**STAFF REPORT: MAY 13, 2020 MEETING**

**VIOLATION NUMBER: 19-332**

**APPLICATION NUMBER: 19-6532**

**ADDRESS: 2415 SEMINOLE**

Diagram showing the dimensions a replica wooden window.

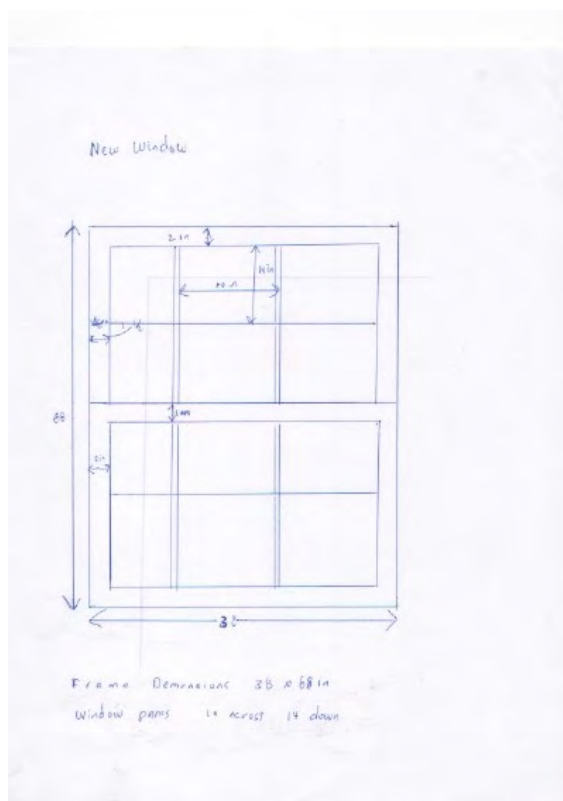
- **Install New Window:** The window is proposed for the south side of the home... Many of the shutters on the south side of the home are missing or damaged. It is unclear whether shutters will be installed on the proposed window and what the plan for the rest of the shutters will be. It appears that the shutters have been removed since the initial application.

- **Window Installation:** The documentation provided illustrates that a window was likely located at this location and staff recommends a Certificate of Appropriateness based on Secretary of the Interior's Standards for Rehabilitation, specifically numbers 2) *The historic character of a property shall be retained and preserved. The removal of historic materials or alteration of features and spaces that characterize a property shall be avoided* and 9) *New additions, exterior alterations, or related new construction shall not destroy historic materials that characterize the property. The new work shall be differentiated from the old and shall be compatible with the massing, size, scale, and architectural features to protect the historic integrity of the property and its environment.*
